# MEMORANDUM

Date: March 10<sup>th</sup>, 2025  
To: City of Madison Heights Planning Commission  
From: Matt Lonnerstater, AICP – City Planner  
Subject: Major Site Plan PSPR 25-01– 32650 Stephenson Hwy – Residence Inn Conversion to Multi-Family Residential [Plan Date 2/10/25]

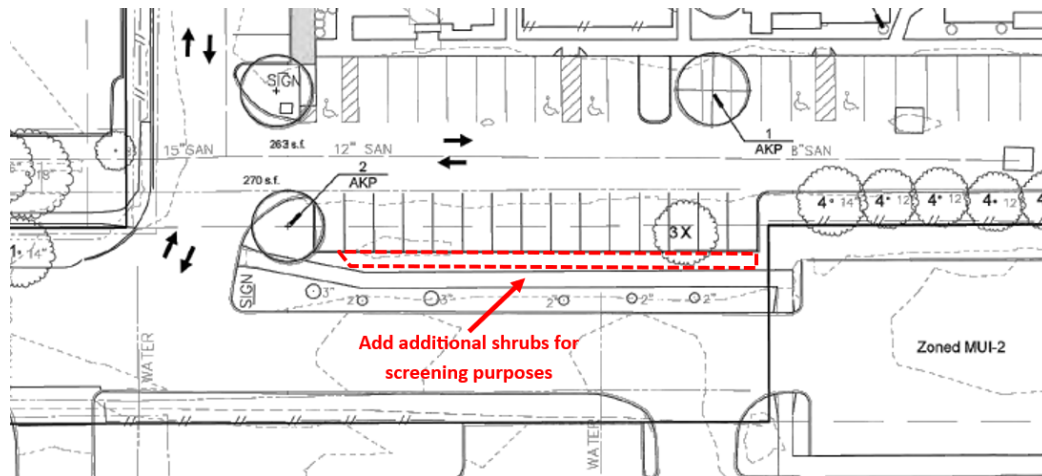
In terms of perimeter landscaping, staff believes that additional shrubs should be installed adjacent to the new parking area along the southern property line, which would shield headlights shining onto the adjacent hotel use. Refer to the image below.

- f. Install additional shrubs adjacent to the new parking area along the southern property line to shield headlights shining onto the adjacent hotel use.
